STAFF'S REQUEST ANALYSIS AND RECOMMENDATION

07PR0405

Rob Chesson (Bailey Park-Rastek)

Approval of building elevations, lighting plan, and landscape plan as required by Conditions 4, 5 and 7, respectively, of Zoning Case 85S074, for eight (8) retail and office/warehouse buildings totaling approximately 77,240 square feet.

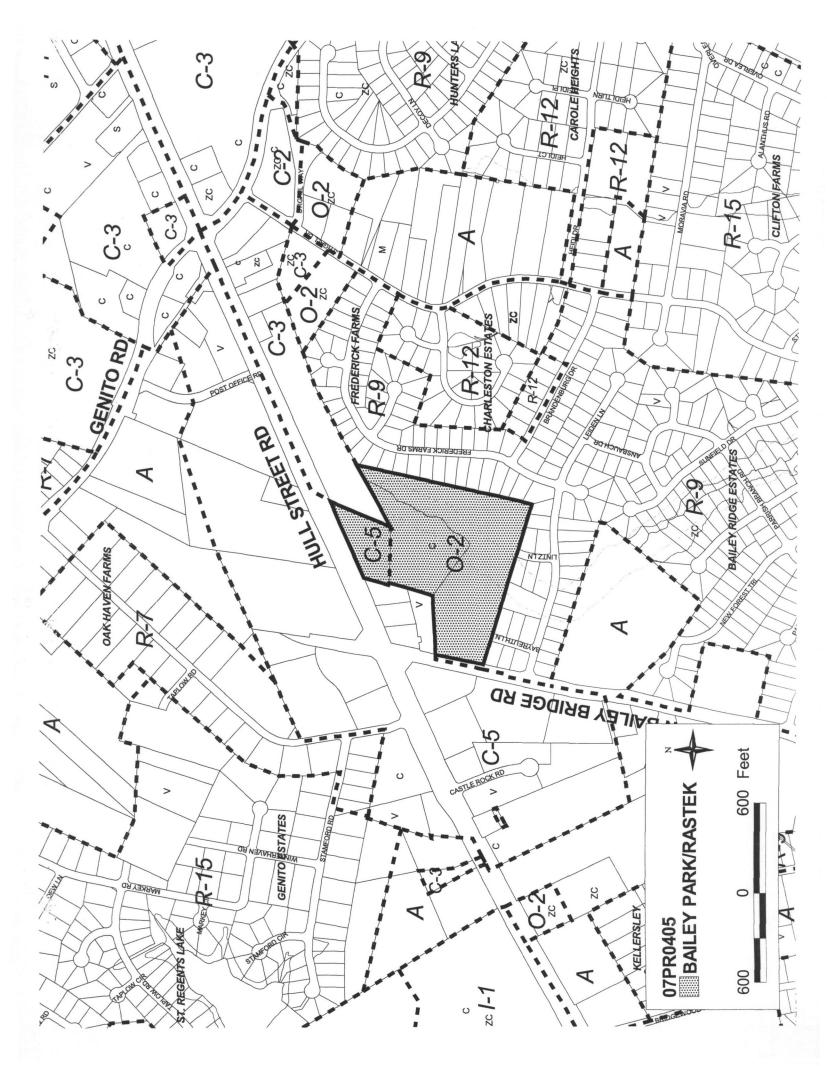
With regards to architecture, Condition 4 of Case 87S074 states that architecture shall have an architectural style and use materials and colors that are compatible with adjacent residential development. The adjacent houses are one (1) and two (2) story houses without a clear identifiable style and are primarily constructed with different types of siding with asphalt shingle roofing. The applicant seeks to upgrade to masonry and use a green standing seam metal roof as shown in Exhibit A. The appearance is similar to commercial buildings in Bellgrade at Huguenot Road and Robious Road. Staff believes that this appearance is compatible with residential development and will establish a strong image for the project. Some of the buildings to the interior of the site are larger in width and are not as visible to public roads and adjacent residential development. The applicant has

proposed that these buildings use only a parapet wall to screen the flat roof. Staff believes that this is not abiding with Condition 4 of Case 87S074. Staff does believe that certain angles of view of these wider buildings should incorporate roof design elements to make the appearance compatible with the more visible Bellgrade style buildings proposed on the site. Staff recommends Architecture Condition Two (2) to address the inclusion of roof design elements into the elevation labeled as Exhibit B.

- 1. Buildings 1, 2, 4 and 8 shall be of a design similar to the elevation labeled as Exhibit A. (P)
- 2. Buildings 3, 5, 6 and 7 may include parapet walls as shown in Exhibit B as long as green standing seam metal roofing is used to create gable or hip roof design elements at visible locations with tower elements, false roofs, or canopies attached to the wall or parapet as approved by the Planning Department. (P)

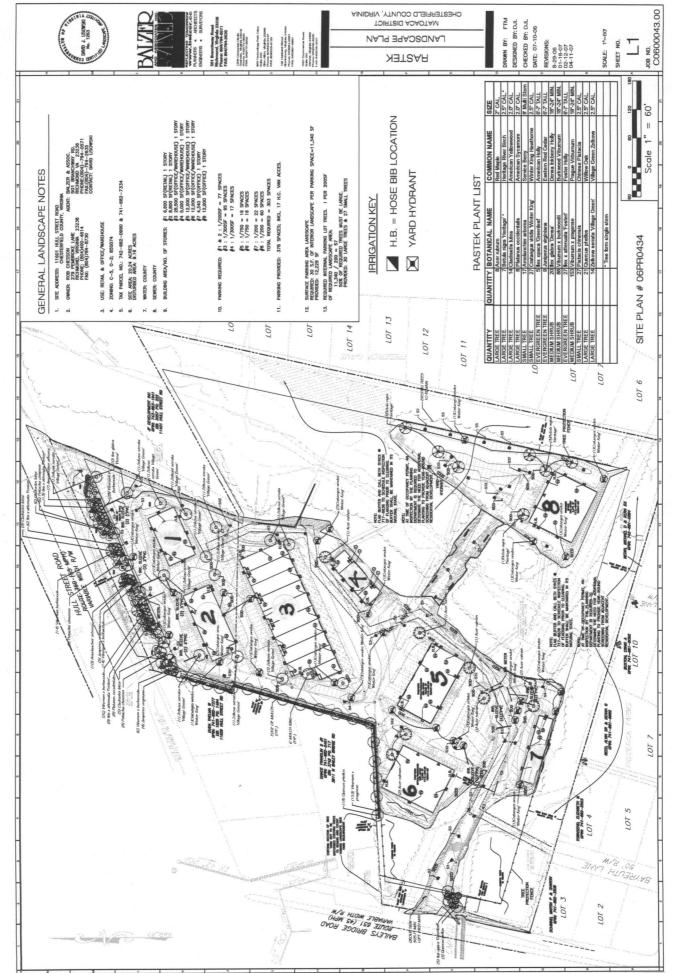
The zoning condition about landscaping (Condition 7) only addresses a thirty (30) feet buffer along Bailey Bridge Road. The site plan and landscaping plan show that a much larger tree save area is occurring along Bailey Bridge Road with additional landscaping at the new entrance into the development. The applicant has provided an overall landscaping plan that addresses a plan review requirement by staff for the replanting of the setback along Hull Street Road at a rate of two (2) times Perimeter landscaping C. Lastly, staff recommends a condition that requires a Planning Department inspection of the seventy-five (75) feet buffers adjacent to the residences in late fall to determine how much evergreen landscaping should be installed to provide year round screening (per Condition 3 of zoning Case 87S074).

- 1. The front setback along Hull Street Road shall be landscaped at a rate of two (2) times Perimeter landscaping C. (P)
- 2. The buffer areas adjacent to buildings seven (7) and eight (8) shall be inspected in late fall 2007 by the Planning Department to determine the amount of supplemental evergreen landscaping the applicant shall provide to accomplish year round screening of these buildings. Evergreen landscaping shall be planted in early spring 2008. (P)
